HYBRID MEETING OF THE BIRMINGHAM PLANNING BOARD
WEDNESDAY, JULY 28, 2021
7:30 PM
COMMISSION ROOM - 151 MARTIN STREET, BIRMINGHAM MI, 48012

SUBJECT: 325 S. Old Woodward – Adachi – Special Land Use Permit Amendment, Final Site Plan & Design Review

RE: Final Site Plan Review Comments
325 S. Old Woodward, Adachi Outdoor Dining

Site Plan

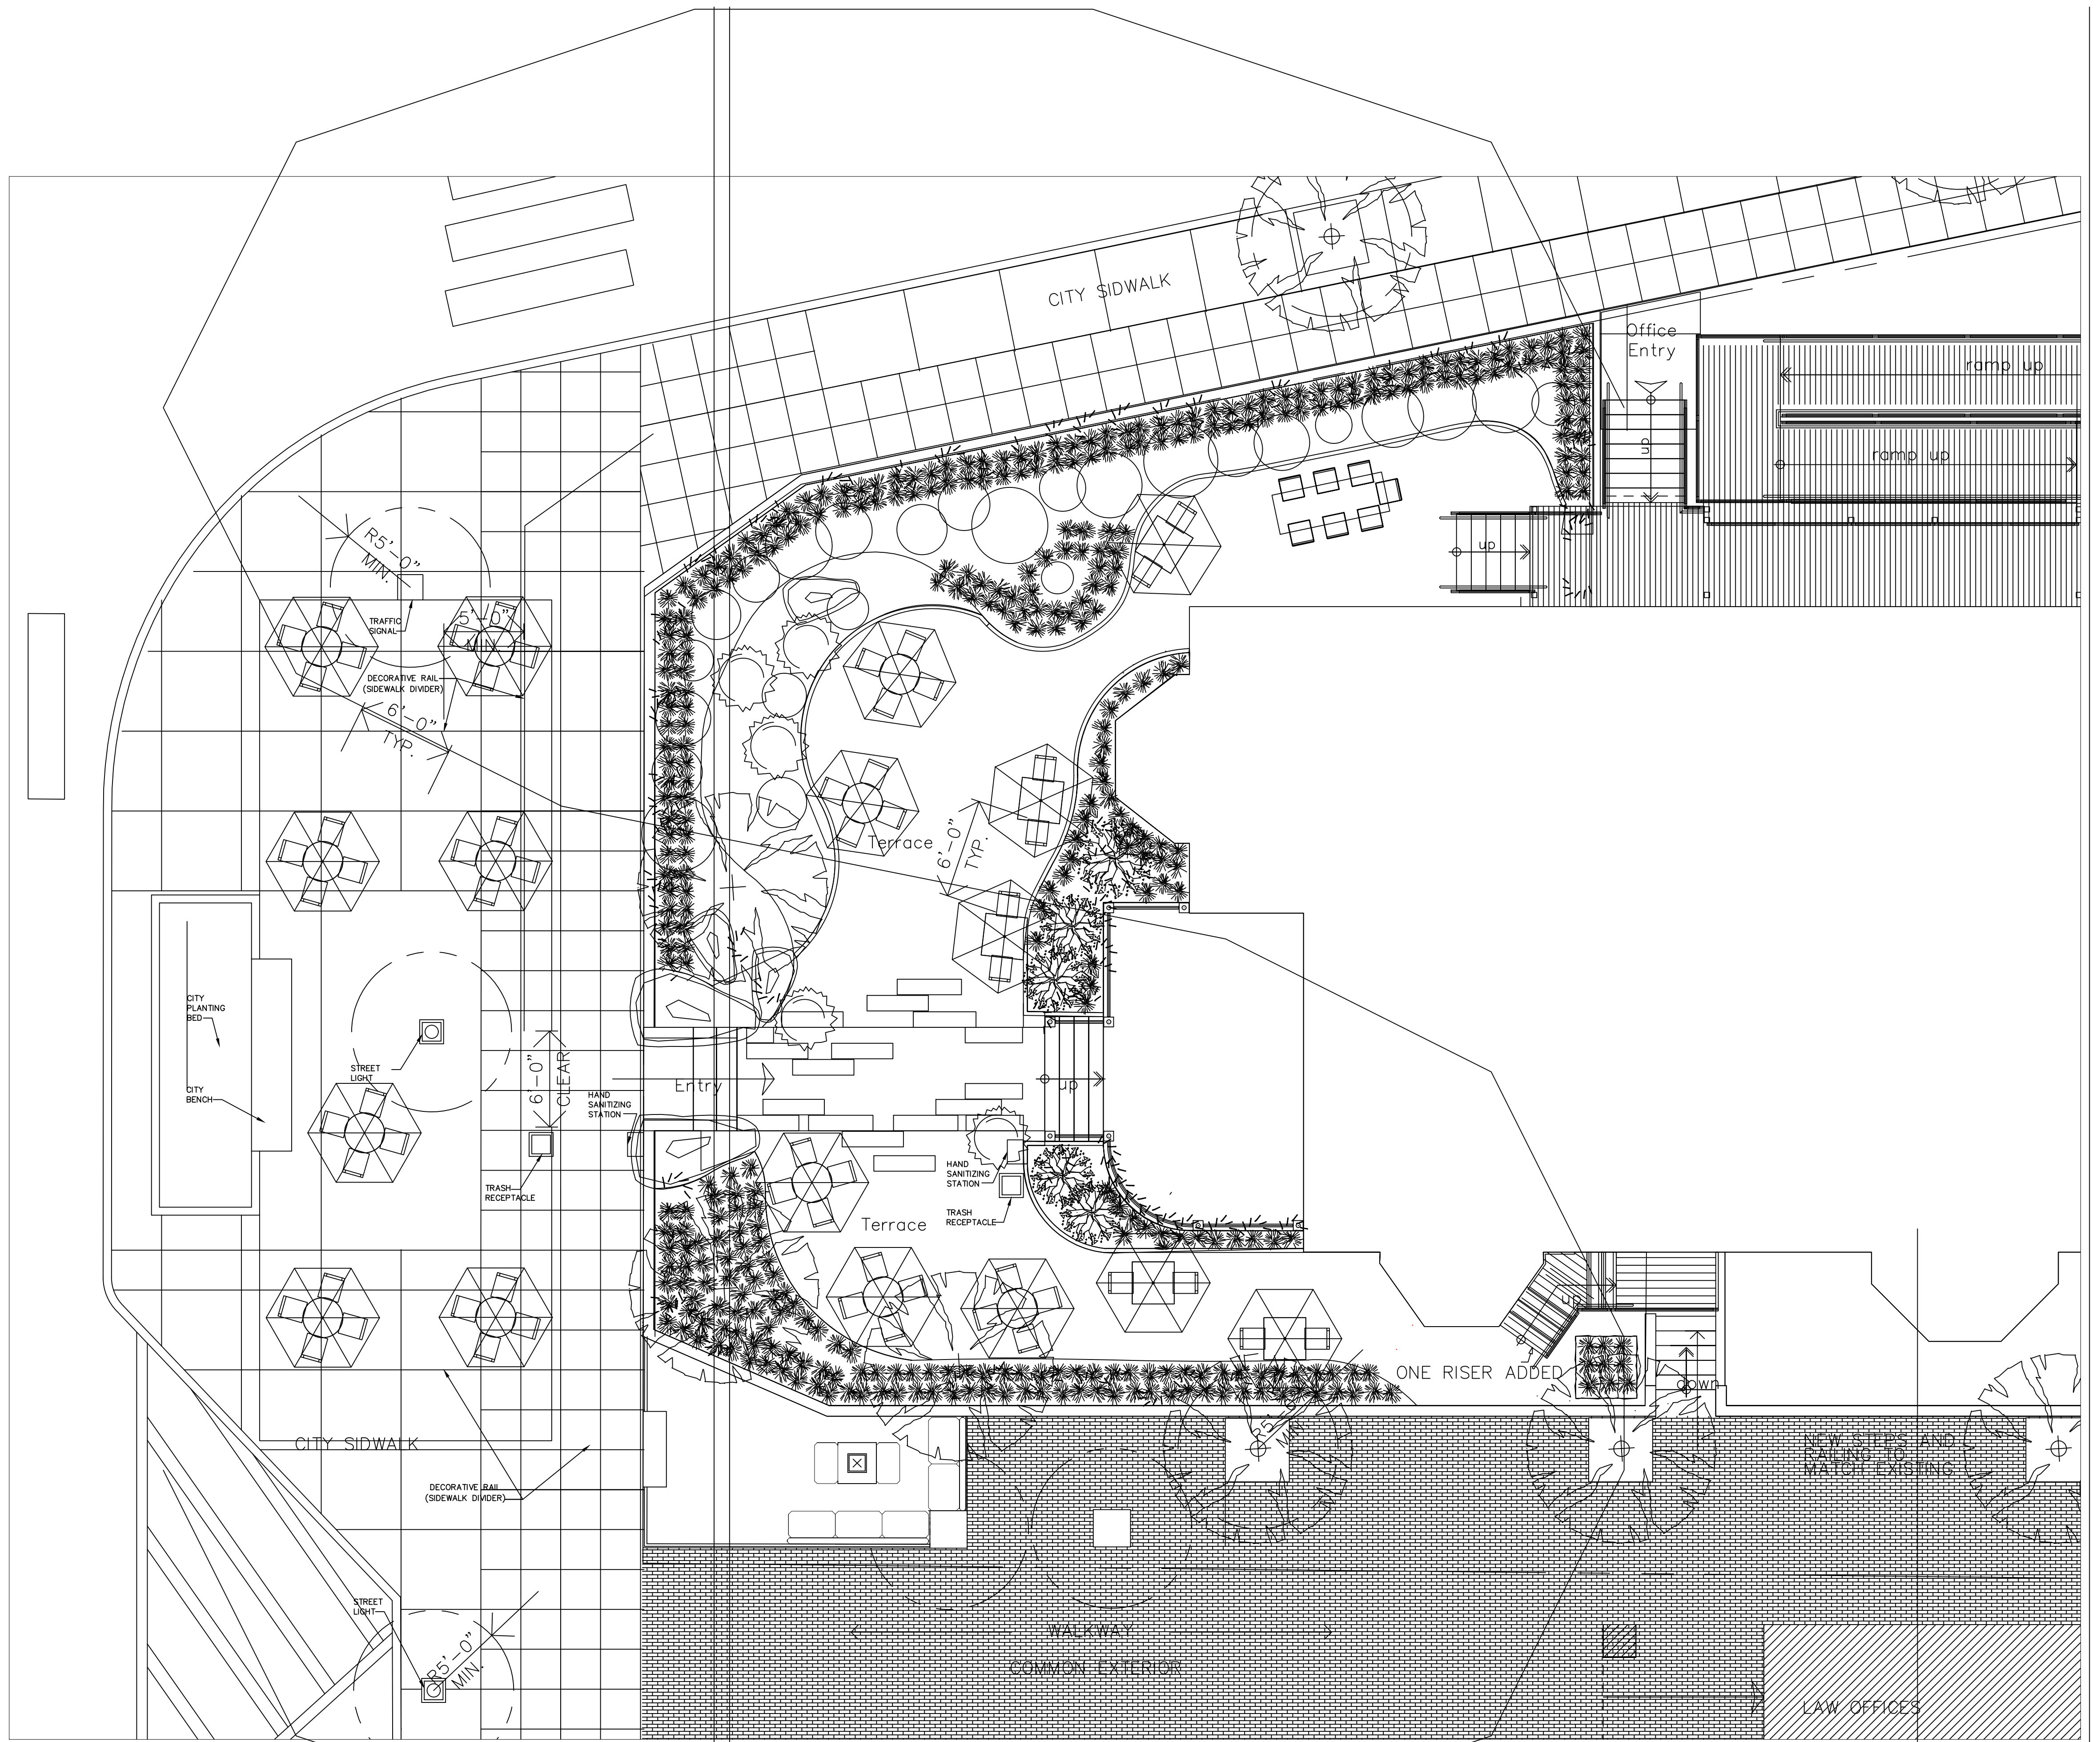
An additional proposal brought forth by the applicant is a raised platform at the south end of the property within the via adjacent to the building. The applicant has advised that this area will be for lounging/waiting only and that no service will be provided in this area. The plans submitted show a 5-seat lounge couch with a fire table. The platform itself is constructed of Trex decking (Brazilian Walnut) and is enclosed with the same railing as the sidewalk area. If the couch were to be considered as outdoor dining, the additional 5 seats would put them 5 over the permitted outdoor seating for a bistro at 70 outdoor dining seats. **The Planning Board should discuss the lounge/waiting area and the potential for it to be used as outdoor dining.**

1. Do not block any path of egress from the building to a public way.
2. The deck on the south side of the plan shows what appears to be a fire table (detail with "x"). Open flame devices are prohibited on combustible structures and shall be a minimum of 15 feet from a combustible structure. Fire tables are not allowed on combustible deck. This was discussed with Blake George over a month ago via phone. Fire table(s) denied for this plan.
3. No LP gas tanks allowed on premises. Follow city ordinance for heating devices (pre-COVID ordinance).
4. A site visit may be required for approval.

1. Applicant should verify that the seating in the common exterior walkway does not encroach onto the property to the south. This is the area on private property between the two buildings.
2. The table just south of the street light seems closer to the public bench than it should be.

1. The Planning Board APPROVES the raised platform as a waiting area only. No food or drink service shall be provided to the area.
